**FINAL  
ENVIRONMENTAL IMPACT REPORT**

**HARPER CANYON (ENCINA HILLS)  
SUBDIVISION**

SCH# 2003071157  
PLN 000696

## 2.0 RESPONSE TO COMMENTS

**Figure MR1-2**  
 Geosyntec Study Area Groundwater Flow  
 PMC®

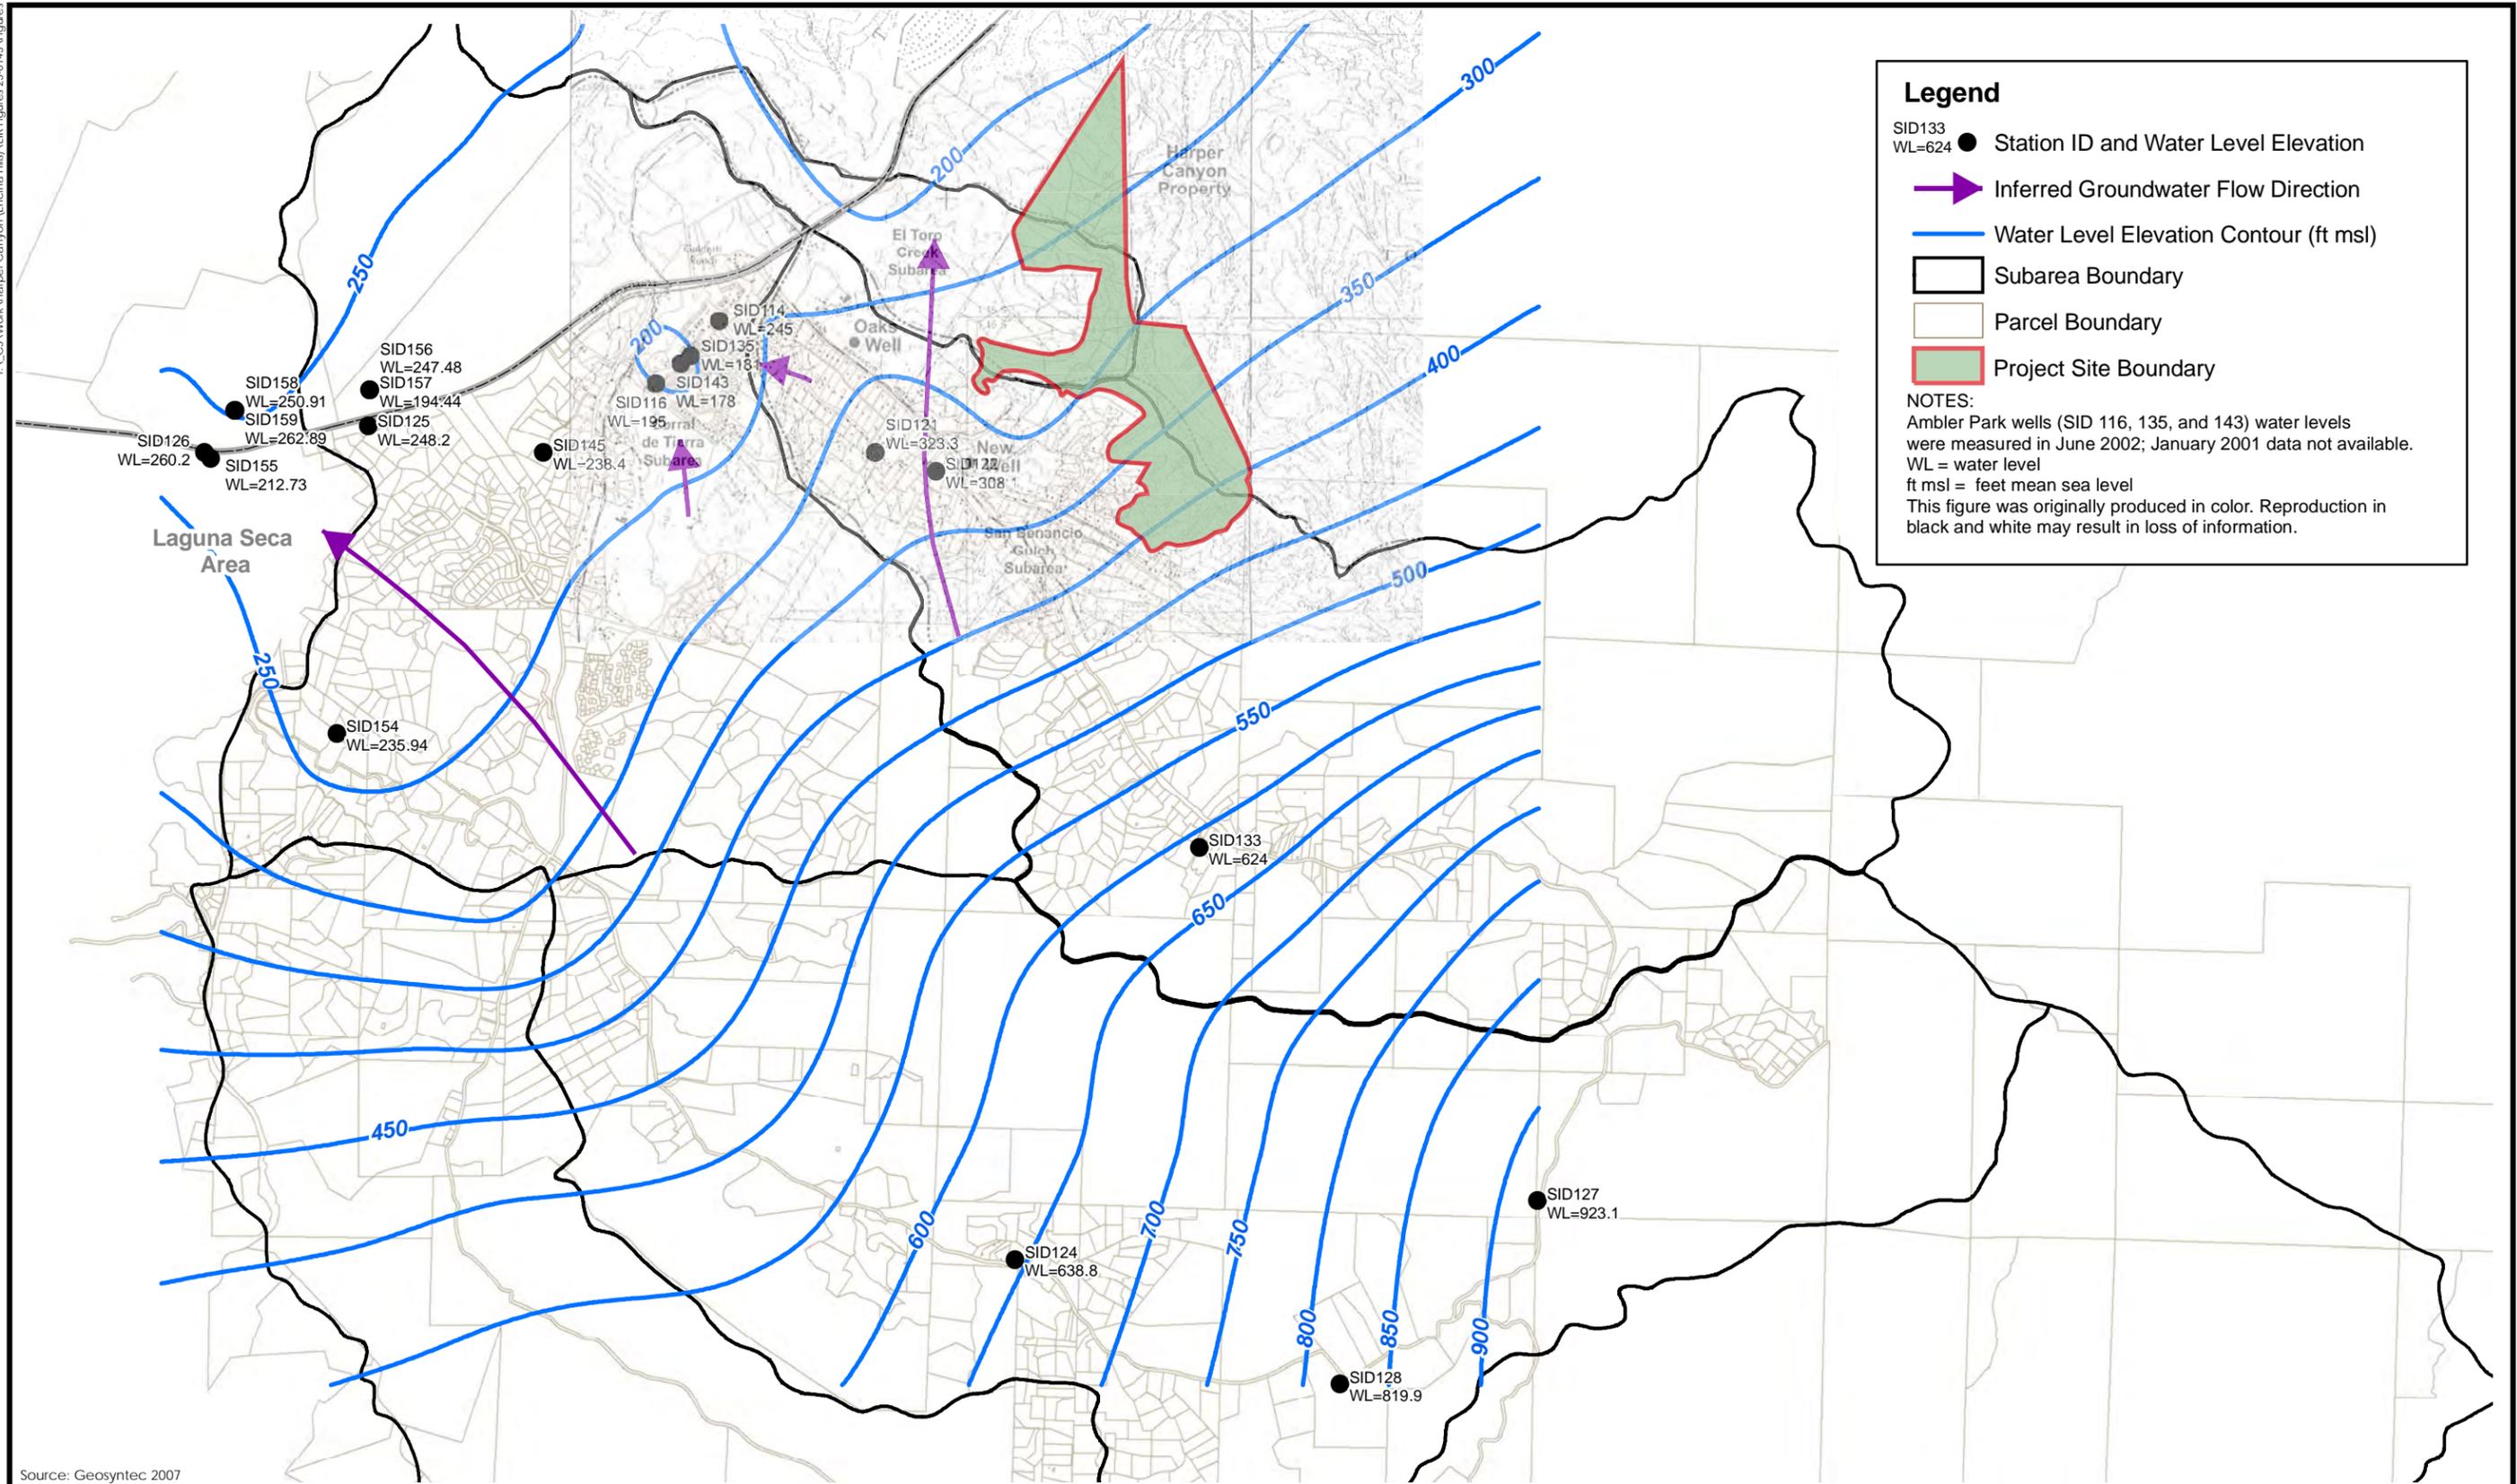
Water-bearing formations in the northeastern portion of the subbasin dip in a northeasterly direction toward the Salinas Valley as shown in **Figure MR1-2**. According to the supplemental geologic map and cross sections (MCWRA 2010), the Plio-Pleistocene Continental Deposits (QTc) (Paso Robles Formation) of the study area show that the hydraulic gradient under the El Toro Creek Valley/State Route 68 corridor is generally northeastward and contiguous with the Salinas Valley Groundwater Basin as shown in **Figure MR1-3**.

**Figure MR1-4**  
Subareas of the Geosyntec Study Area

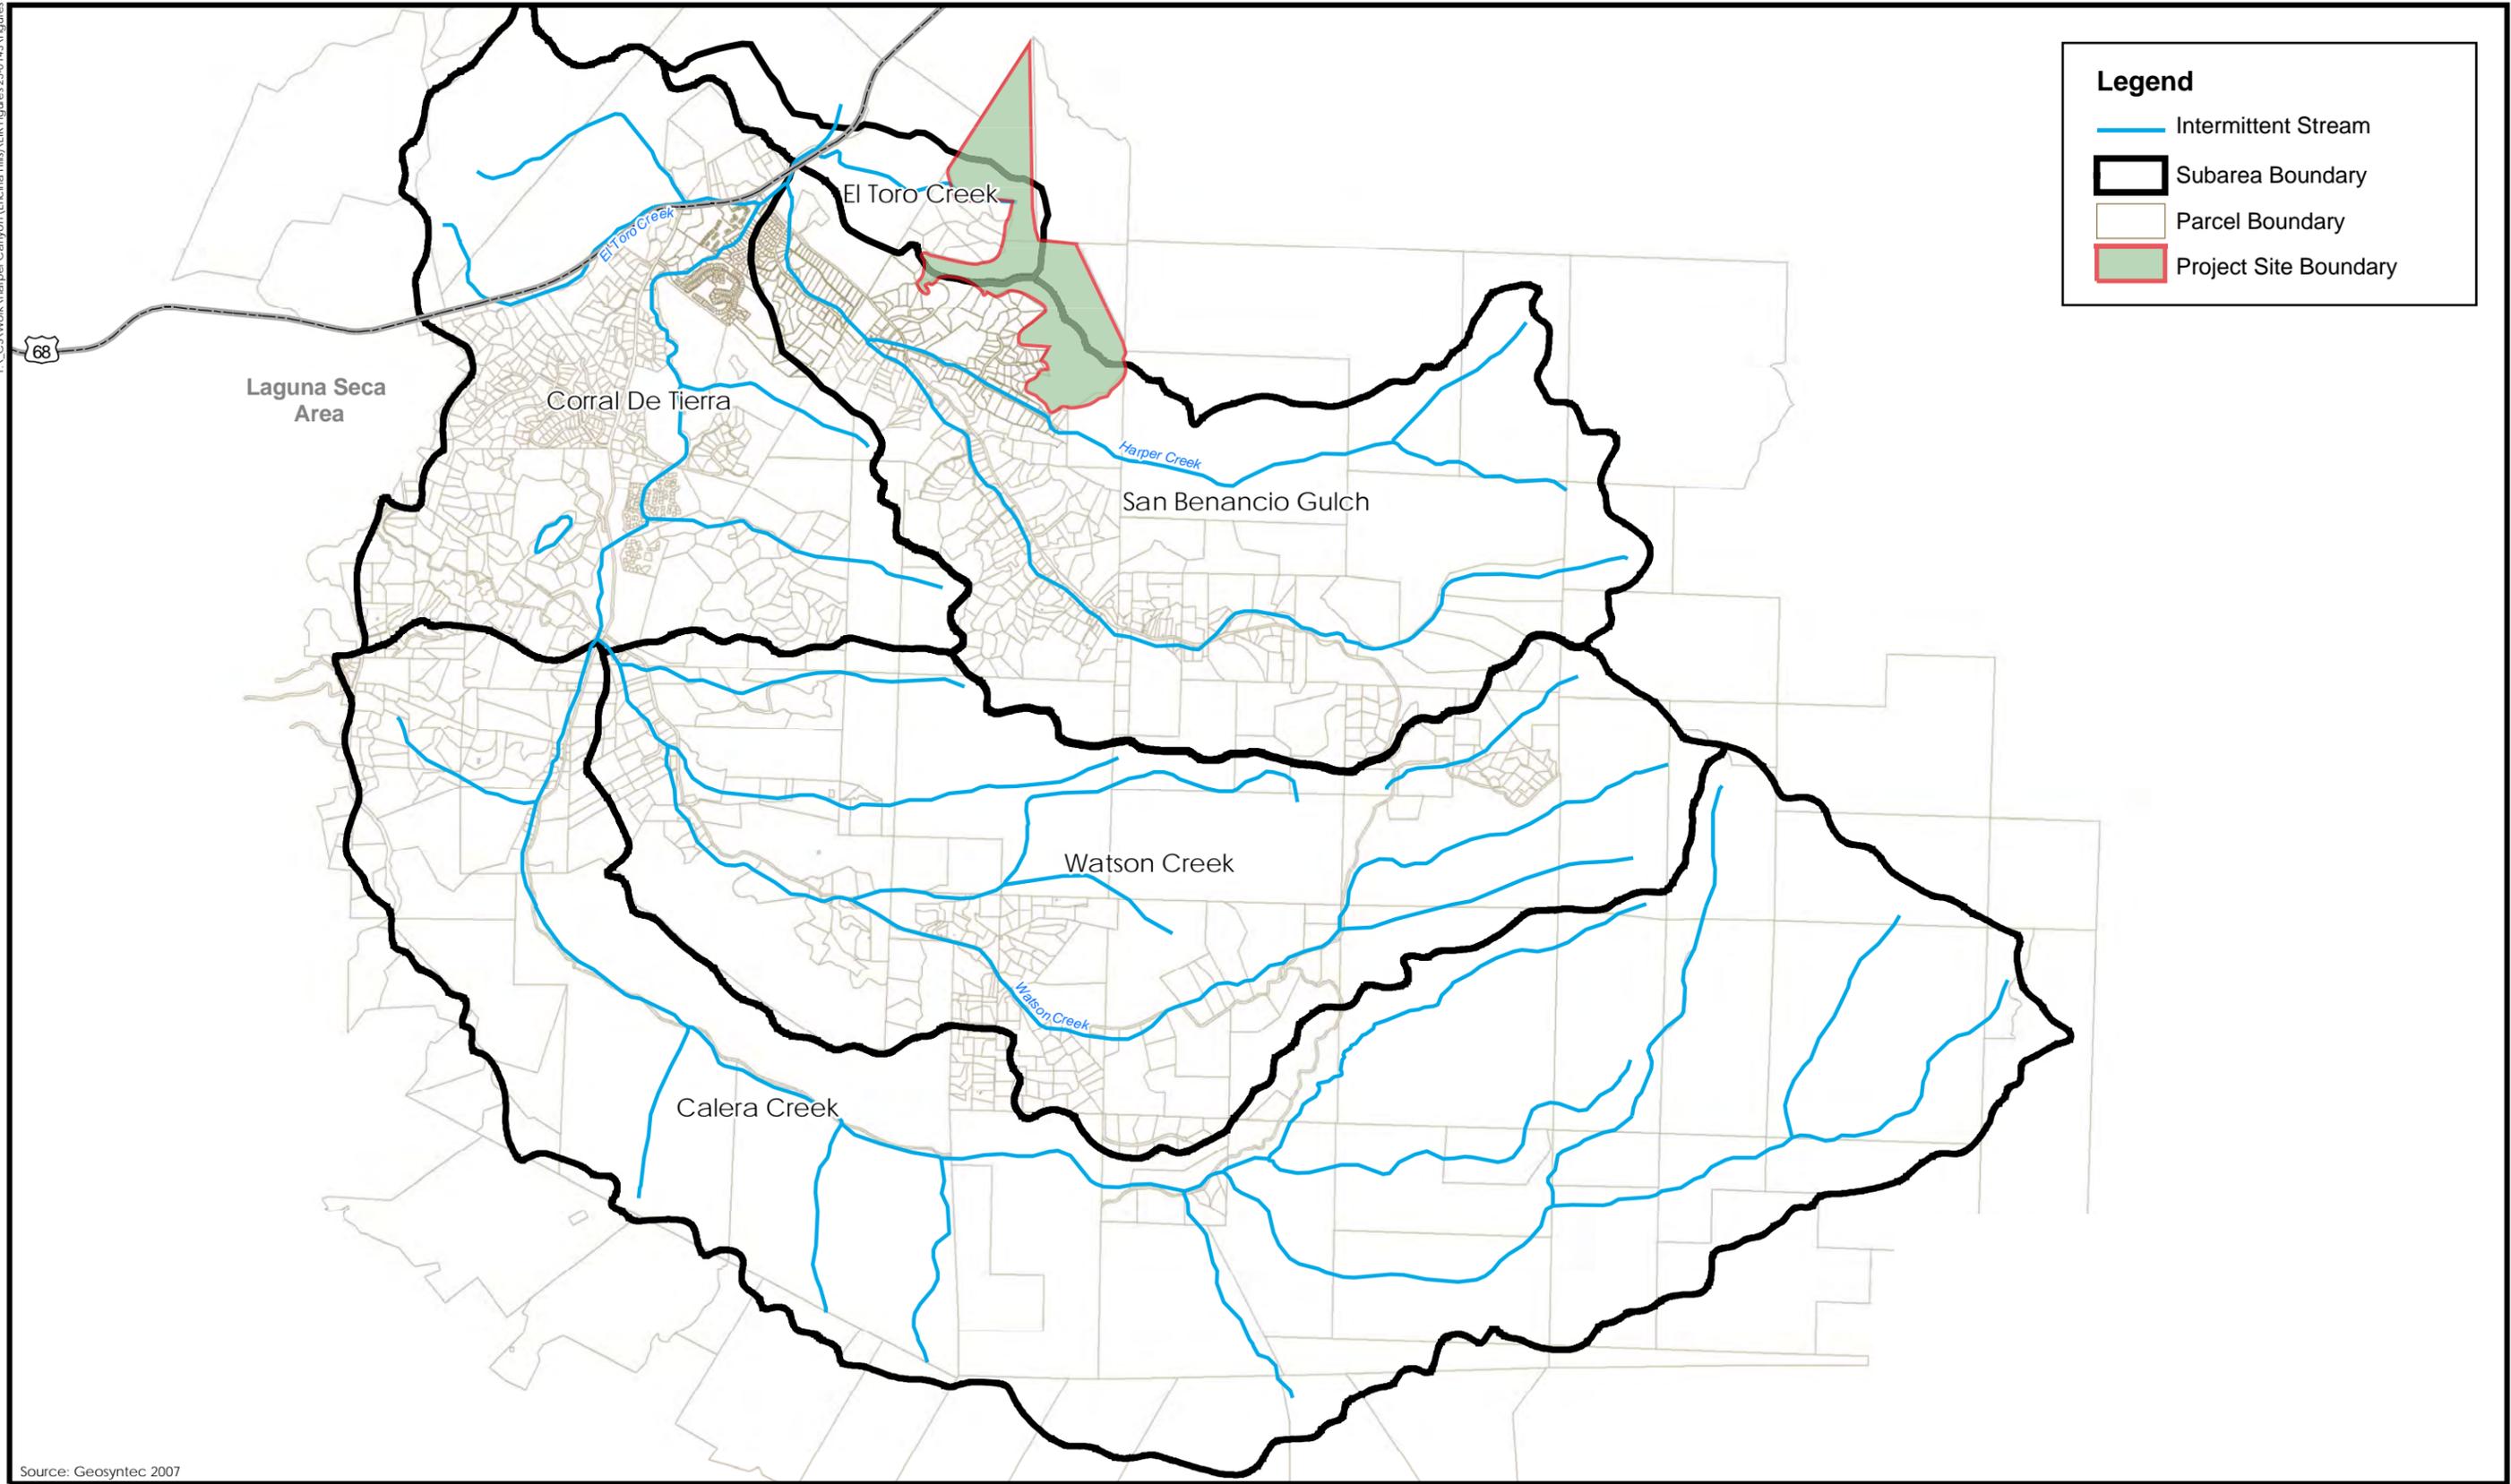
The Geosyntec Study area is divided into five subareas as shown in **Figure MR1-4**. The project site lies within two subareas: the El Toro Creek subarea and San Benancio Gulch subarea; however, the wells that would serve the proposed project are located within the San Benancio Gulch subarea as shown in **Figure 3.6-2** (renumbered and renamed figure) of the FEIR.

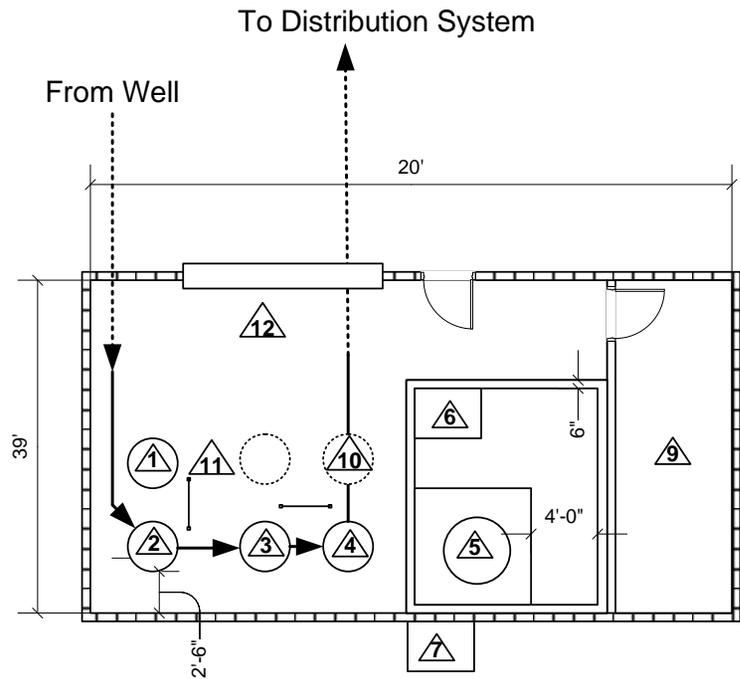
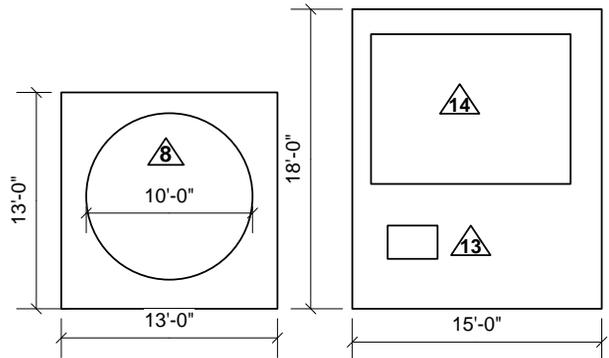
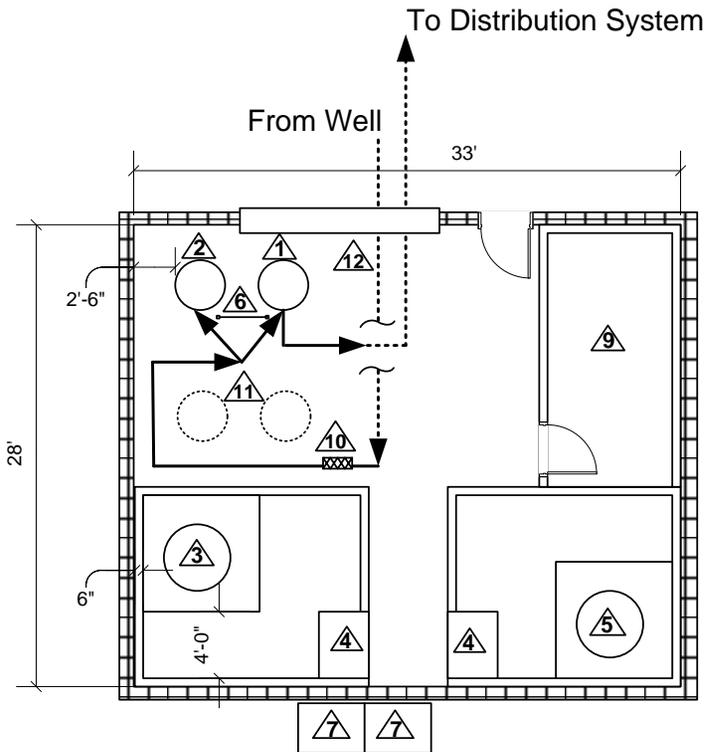
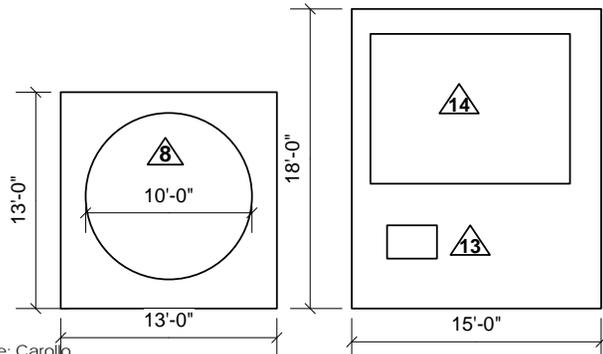
Under Treatment Facility Option B, a new treatment facility would be constructed on the project site within Zone 2C. The treatment facility would be similar to one of the treatment facilities shown in **Figures MR 1-5a-c** and enclosed in an appropriate structure to conceal its appearance. The final design will be based on which type of treatment is chosen. The enclosure would likely be designed to look like a barn or other rural building on the exterior. Maintenance schedules, servicing and disposal of accumulated constituents also differs by treatment method.

The design (type of treatment) and construction of the new treatment facility would be under the jurisdiction of Monterey County Health Department, Environmental Health Bureau. Mitigation measures have been clarified to address this treatment option. The significance conclusions of the EIR remain the same, as all impacts related to water quality remain less than significant (refer to mitigation measures **MM 3.6-2a** through **MM 3.6-2c**). The well and any new water treatment facility, if determined necessary, would then be transferred and operated by Cal-Am (refer to mitigation measures **MM 3.6-2b** and **MM 3.6-2c**). This treatment option would eliminate the need for the project to be served treated water from the Amber treatment plant, eliminate the physical involvement of water from the B-8 zone, and eliminate the need for continuous reporting to the County regarding the equal exchange of water served to the subdivision with water pumped from the wells.

Section 3.6, Groundwater and Hydrogeology of the DEIR has been modified to make minor clarifications as noted in Section 3.0, Amendments of this FEIR. The section also addresses this alternative treatment and delivery option.
